ADDENDUM NO. 2

PROJECT NAME: East Campus Recreation Center Renovation & Addition
UNL PROJECT NUMBER: A016P039
BID INVITATION NUMBER: 2237-13-7200

CONSULTANT: Sinclair Hille & Associates, Inc.
ADDRESS: 700 Q Street
Lincoln, NE 68508

The bid documents, plans dated 8/21/13 and project manual dated 8/25/13, for the above referenced project are amended by this addendum.

Revision to Detail: **A1/A101**

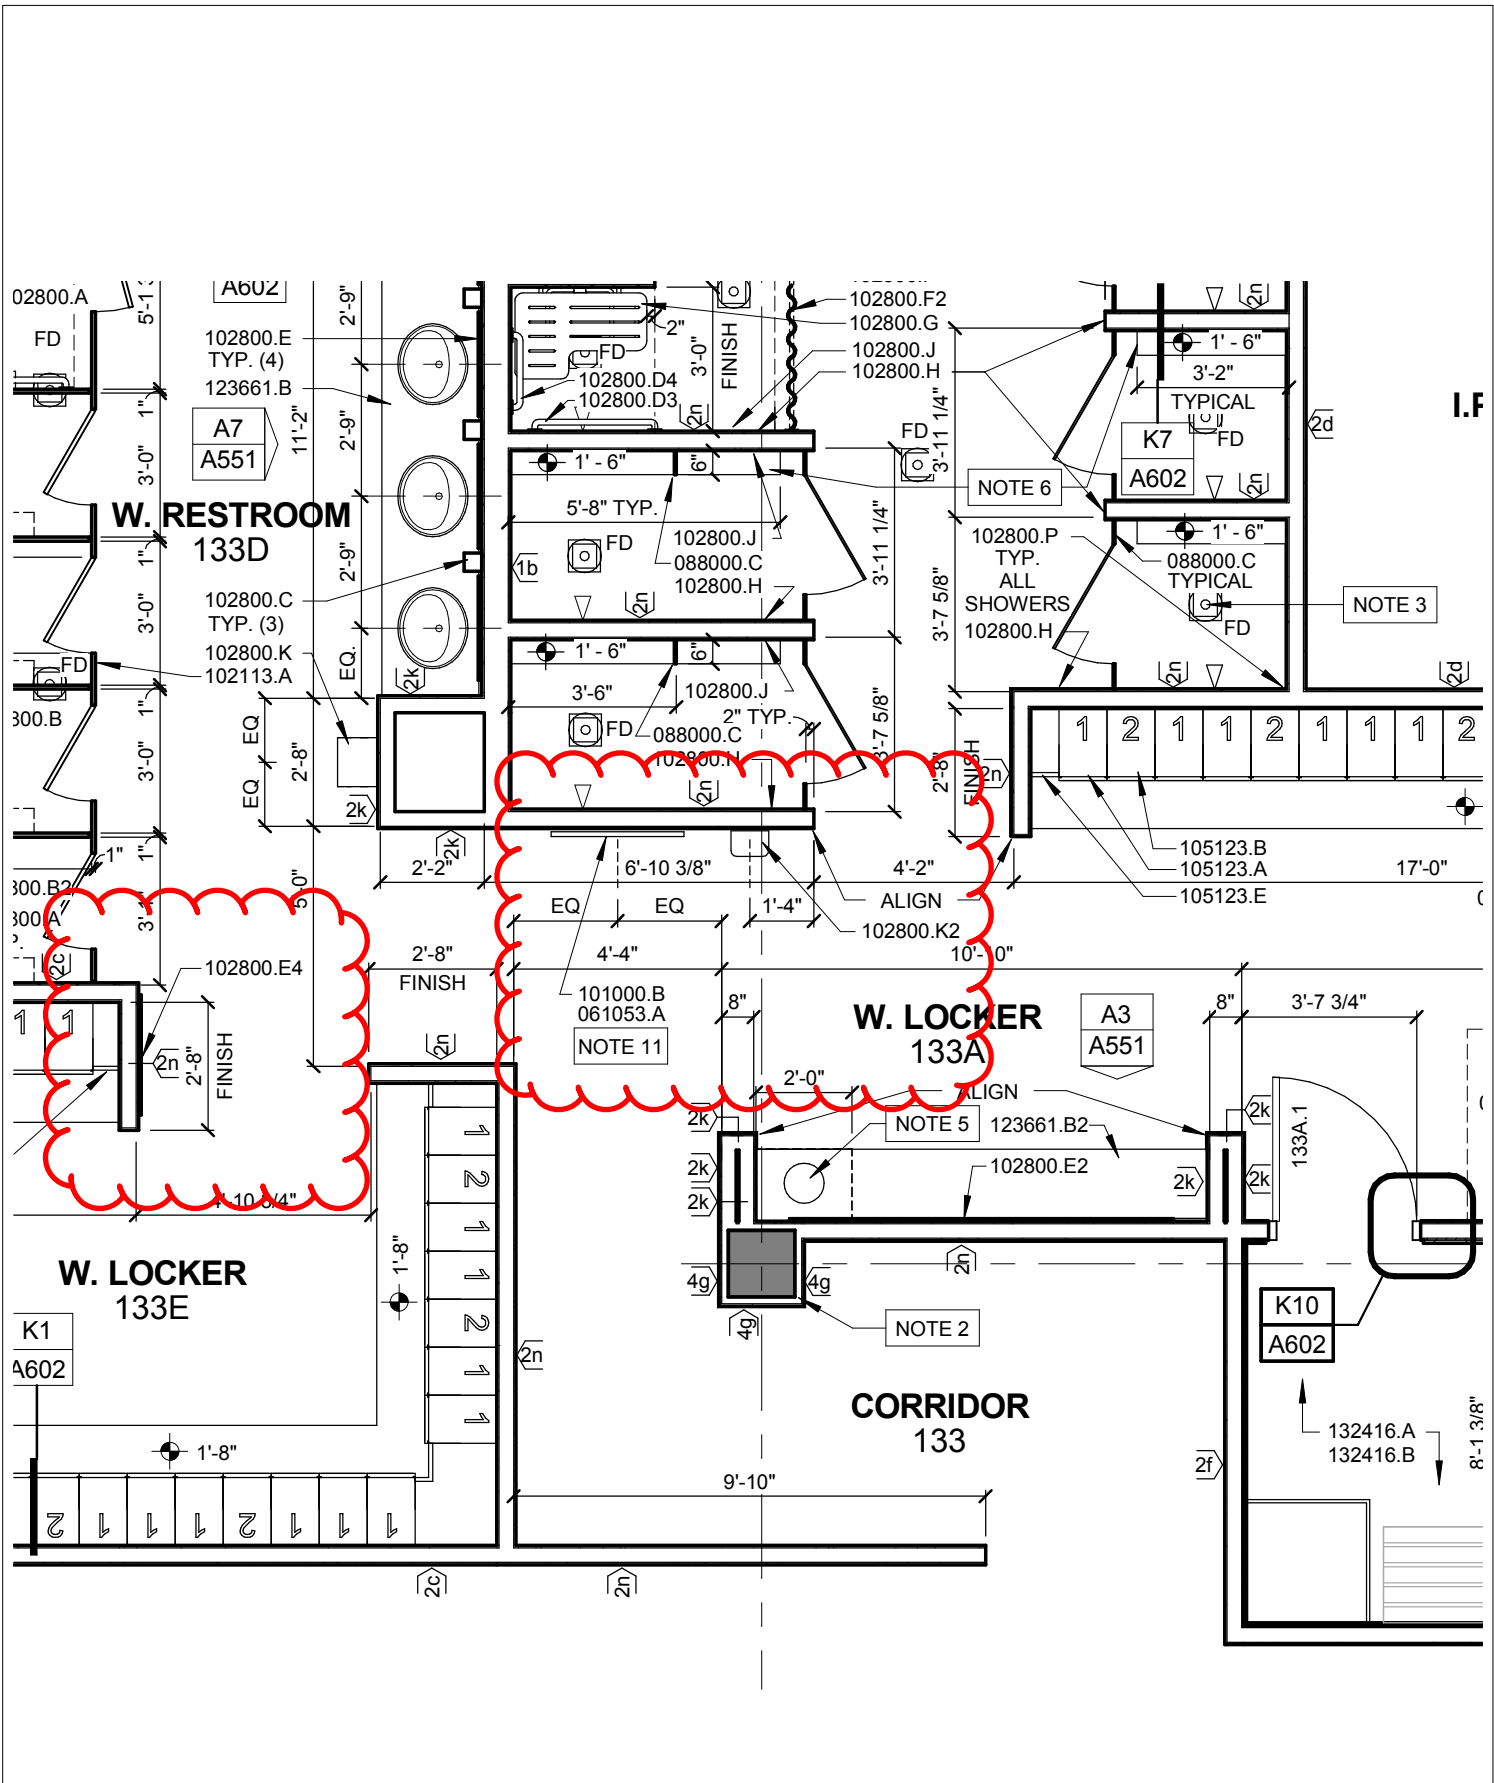
- ADD 2-29.** Refer to A1/A101, Laundry 104A; Add graphic representing cast-in-place drain basin along the west wall along with section callout A4/A602 and vertical dimensions associated with basin. **Refer to Attachment A1.**

<h1>Enlarged Floor Plan</h1>		SINCLAIR hille architects	
Revision to Detail: D11/A151		UNL East Campus Recreation Center Attachment: A3	
Scale: 1/4" = 1'-0"	Project Number: A016P039	Date: September 24, 2013	Attachment to: Addendum 02

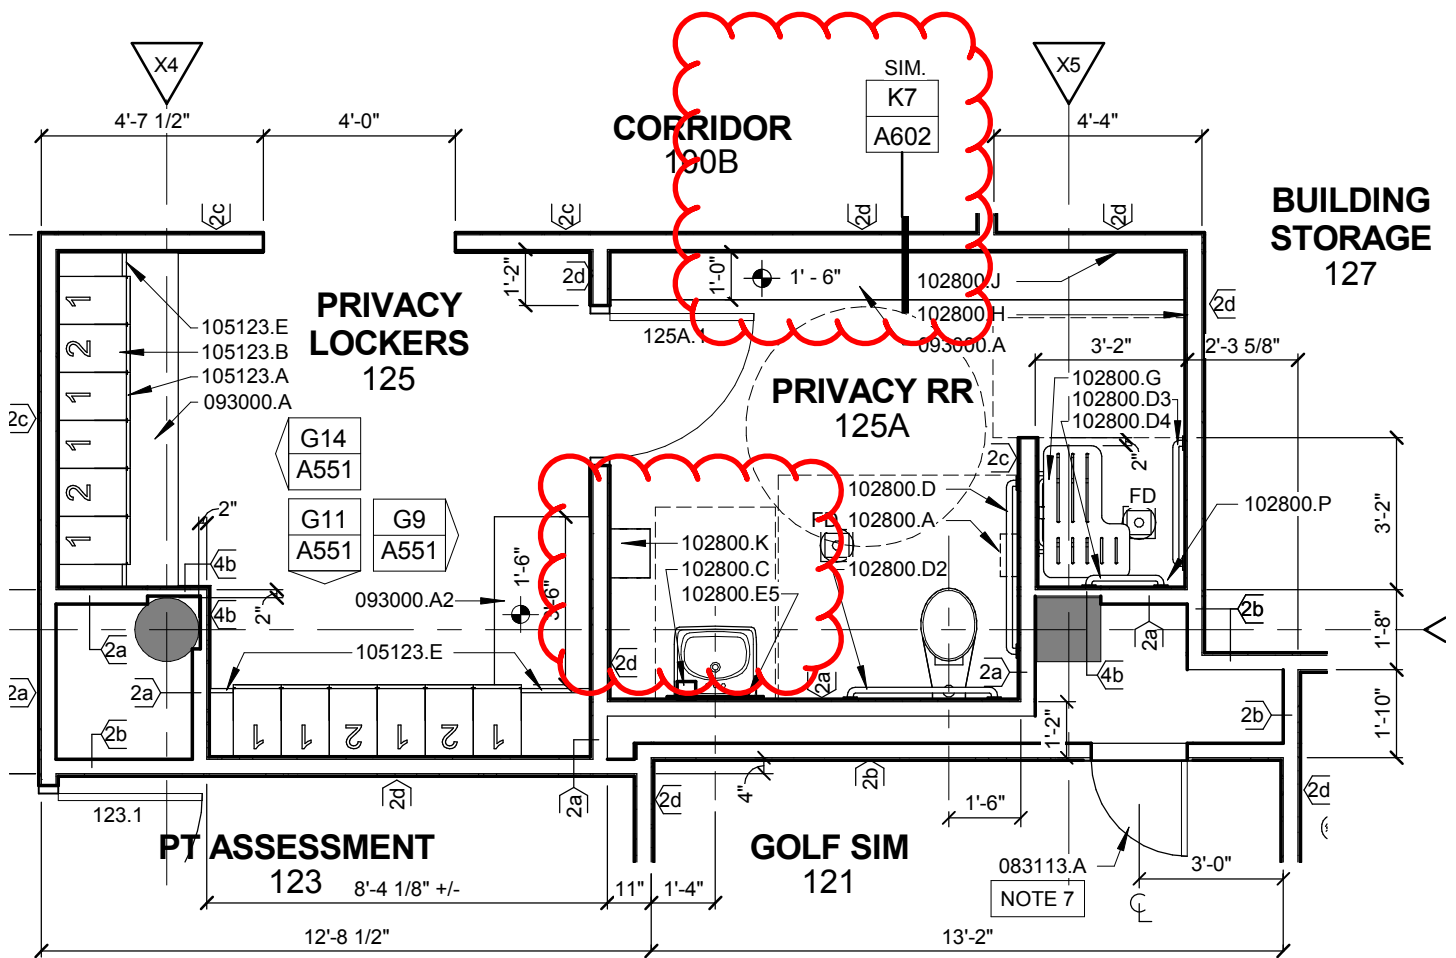
- ADD 2-33.** Refer to D11/A151; As requested by Owner, the door into Sauna 132C has been relocated as shown on **Attachment A2.**
- ADD 2-34.** Refer to D11/A151; Contractor shall provide blocking and labor for installation of Owner provided TV monitor in Men's Locker 132B on the west wall of Sauna 132C as shown on **Attachment A2.** Keynotes 10100.B and 061053.A along with Sheet Note "NOTE 11" have been added along with graphic indication of monitor. Center monitor on wall area between face of lockers and outside corner of Sauna.

- ADD 2-35.** Refer to D11/A151; Mirror 102800.E4 has been relocated to the west wall of Men's Restroom 132A and centered on opening as indicated on **Attachment A2.**

- ADD 2-36.** Refer to D11/A151; Warm air dryer 102800.K has been shifted east to center on wall at Men's Restroom 132A as shown on **Attachment A2.**

- ADD 2-37.** Refer to D11/A151; Add warm air dryer 102800.K2 in Men's Shower 132D and modify wall configuration as shown on **Attachment A2**.
- ADD 2-38.** Refer to D11/A151; Mirror 102800.E4 has been moved from the north wall of Women Locker 133A to the west wall of the entry to Women's Locker 133E as shown on **Attachment A3**.

Revision to Detail: **A11/A151**

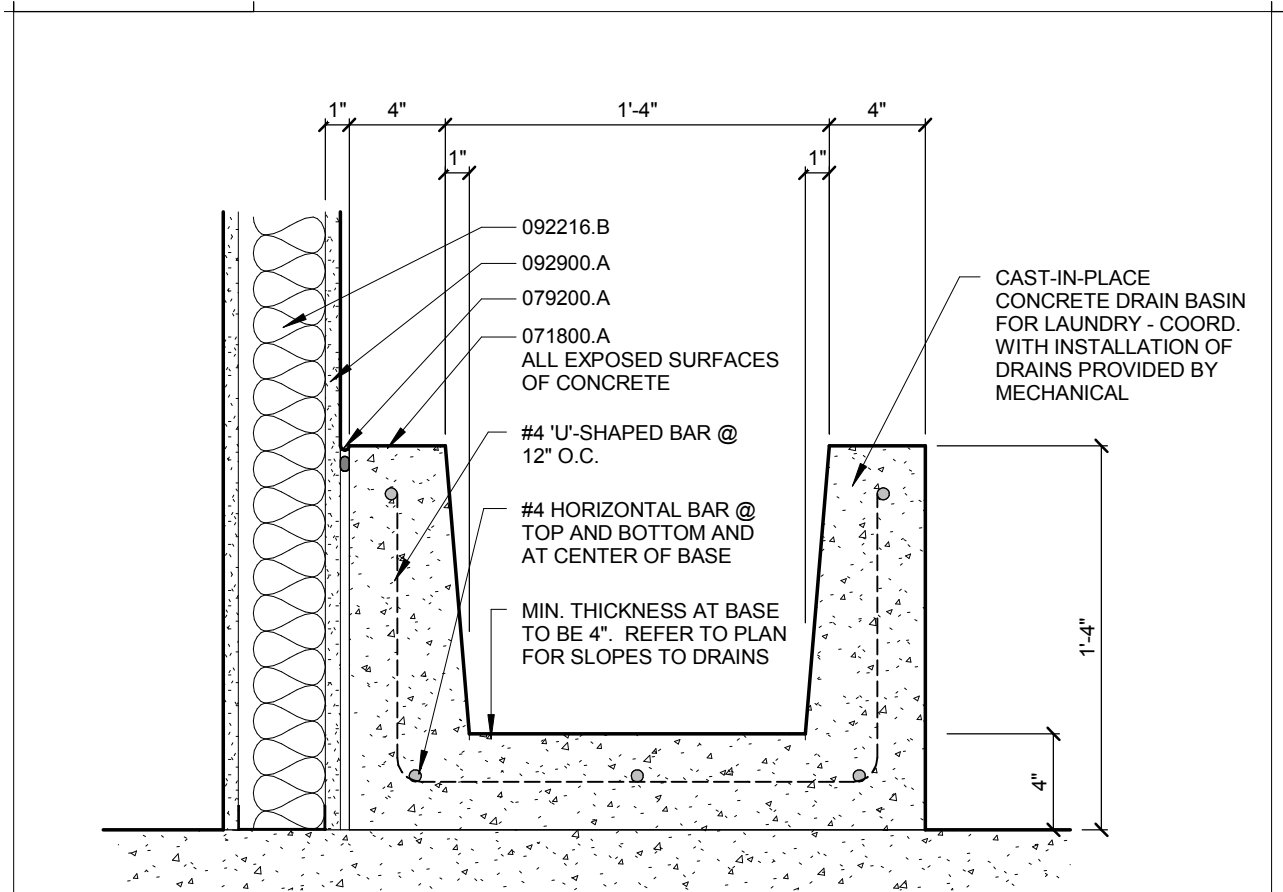
- ADD 2-40.** Refer to D11/A151; Add warm air dryer 102800.K2 in Women's Locker 133A where shown on **Attachment A3**.
- ADD 2-41.** Refer to A11/A151; Replace combination paper towel dispenser receptacle (102800.M) with warm air dryer (102800K) in Privacy Restroom 125A. Refer to **Attachment A4**. Note that dimensional location of wall hung lavatory has also increased from 1'-2" to 1'-4".

Revision to Detail: **NEW DETAIL A4/A602**

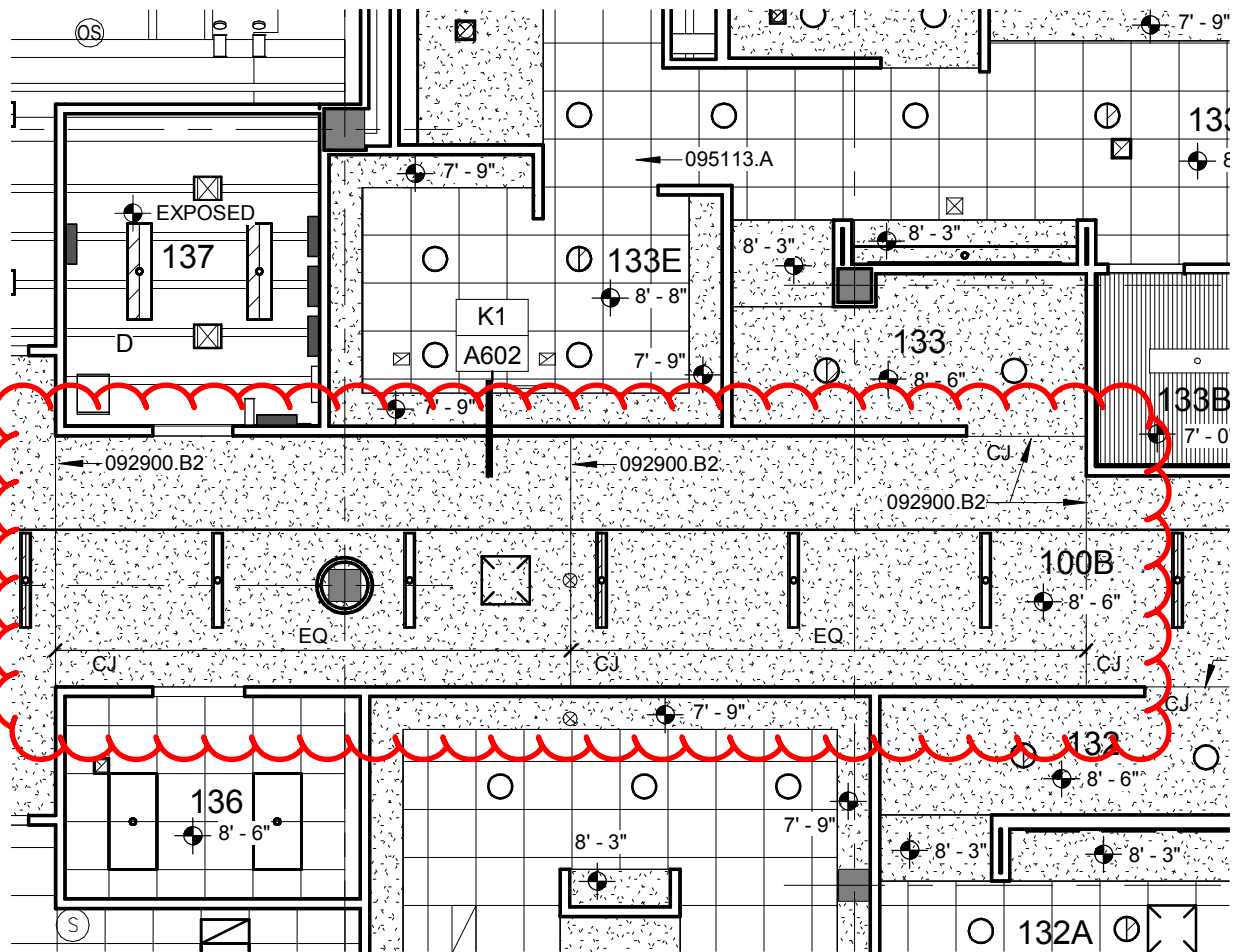
- ADD 2-44.** Refer to Sheet A602; Add Detail A4/A602 to the sheet as shown on **Attachment A5**. In addition to inclusion of the new detail, also add keynote 071800.A to the sheet's keynote legend.

First Level Reflected Ceiling Plan

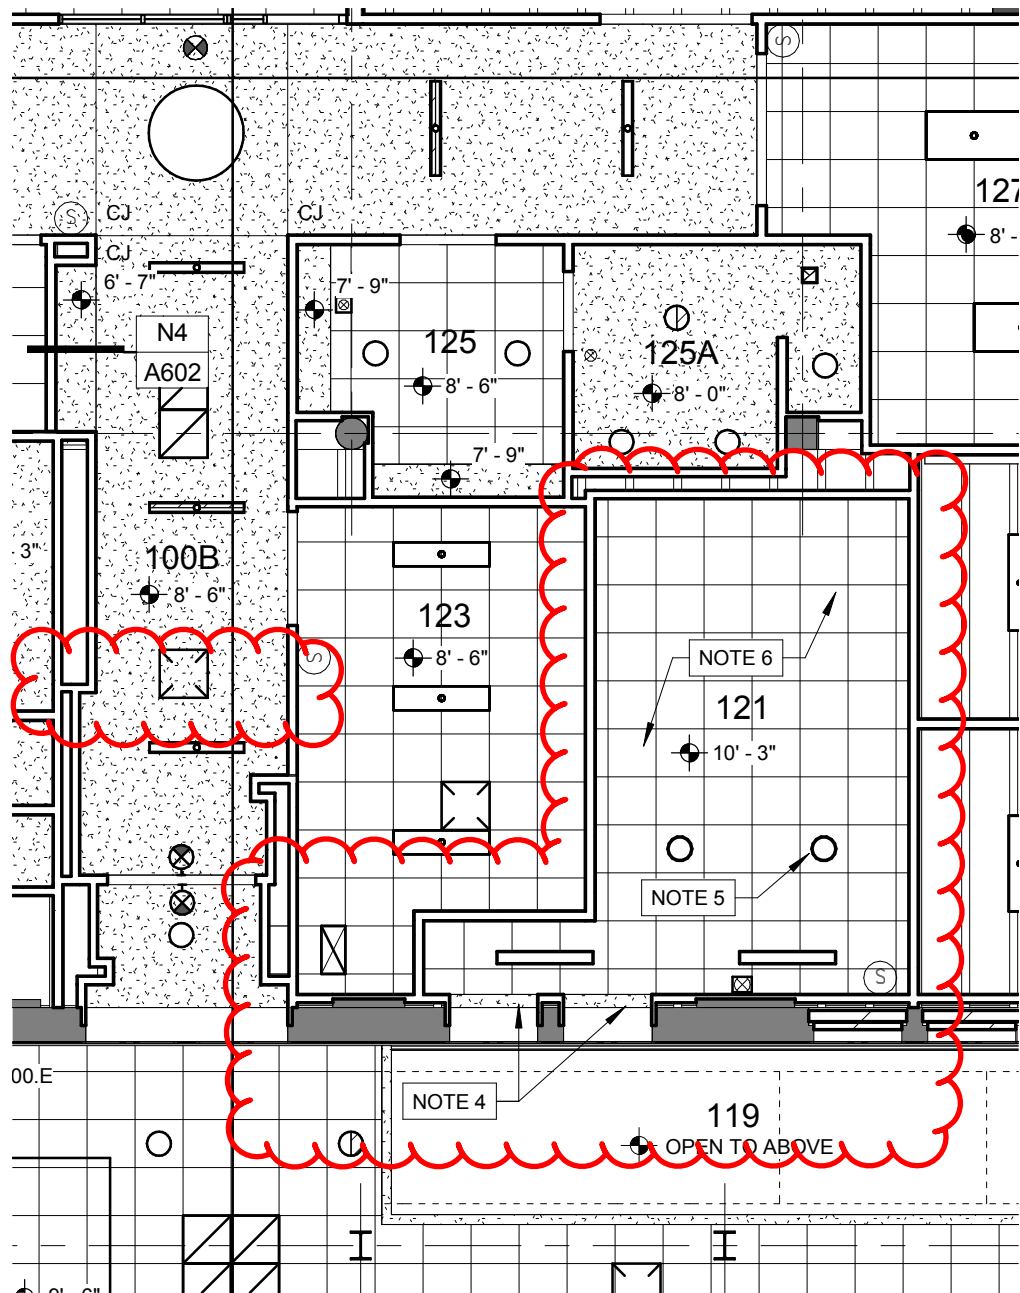
- ADD 2-45.** Refer to A1/A701, Room 100B (east/west corridor); Modify the location of the control joints in the GWB ceiling assembly. The east joint shall be moved east to align with the outside corner of Room 133B and the center control joint shall shift east as required to maintain an equal spacing in the corridor as shown on **Attachment A6**.

PARTIAL SECOND LEVEL FRAMING PLAN

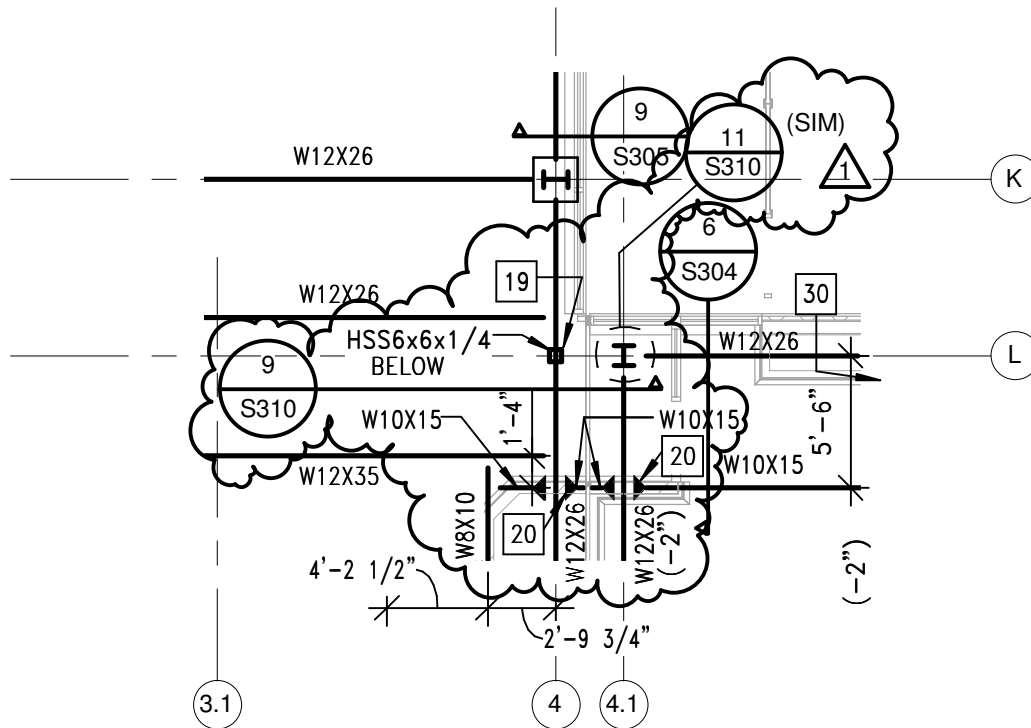
- ADD 2-52.** Refer to Sheet S102, Second Level Framing Plan; At the southwest corner of gymnasium, revise framing, add dimensions and add detail reference as shown on **Attachment S102-A**.

PARTIAL SECOND LEVEL FRAMING PLAN

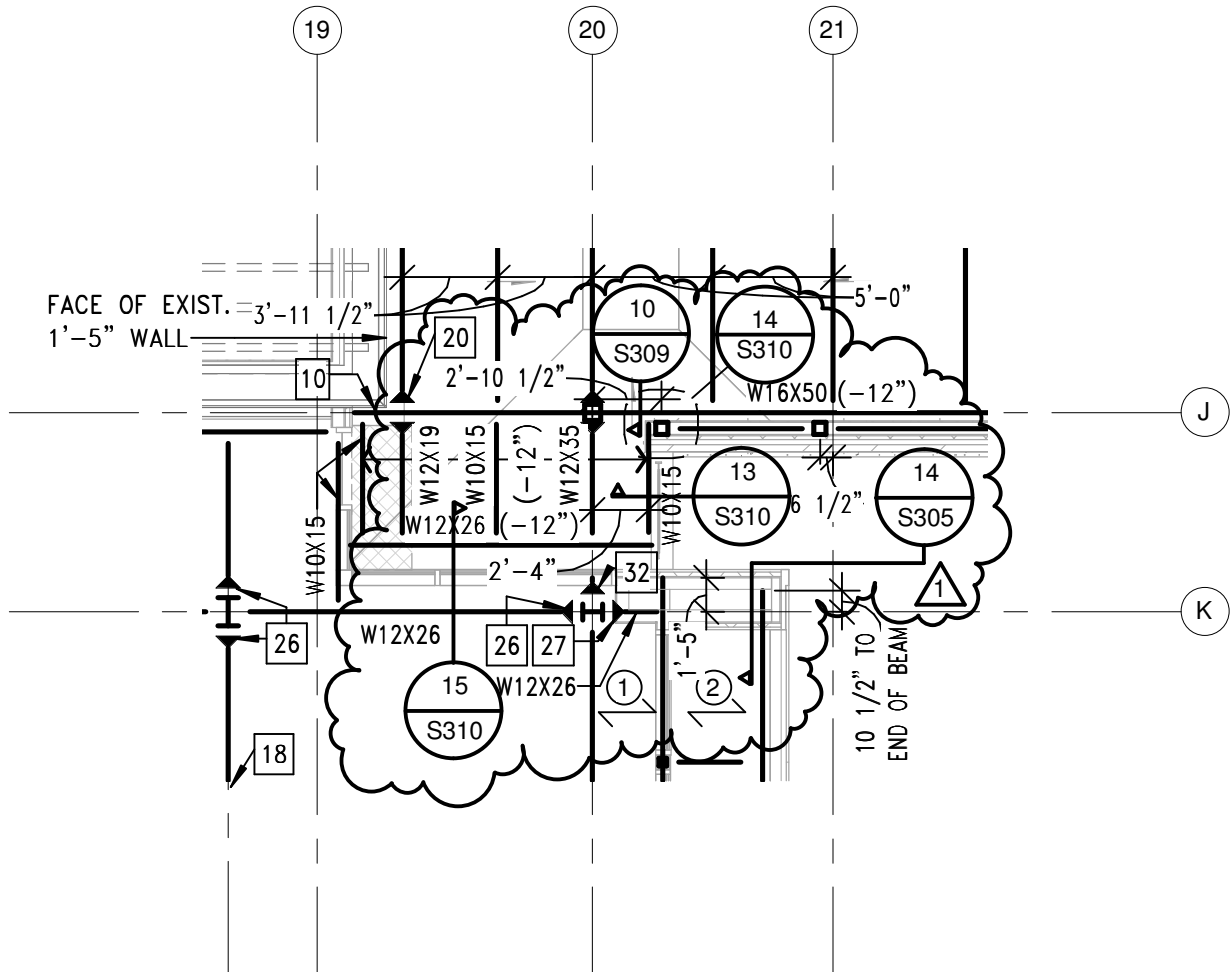
- ADD 2-53.** Refer to Sheet S102, Second Level Framing Plan; At the expansion joint between gymnasium and south addition, revise framing, add plan note reference and add detail references as shown on **Attachment S102-B**.

PARTIAL SECOND LEVEL FRAMING PLAN

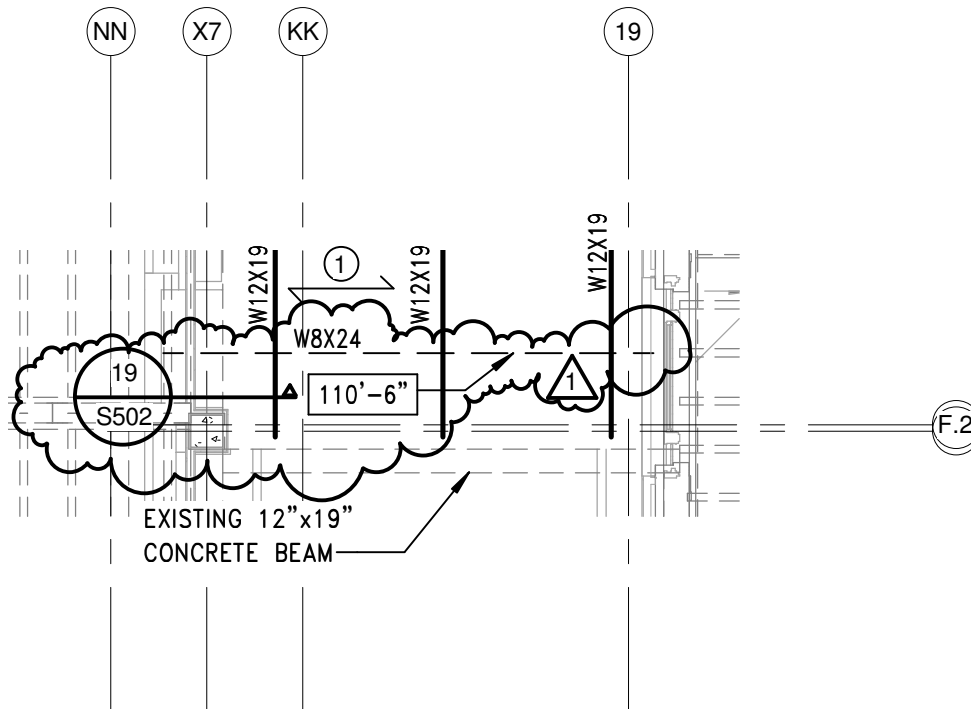
- ADD 2-54.** Refer to Sheet S102, Second Level Framing Plan; At the interface between east addition and south addition, revise framing, add plan note reference and add detail references as shown on **Attachment S102-C**.
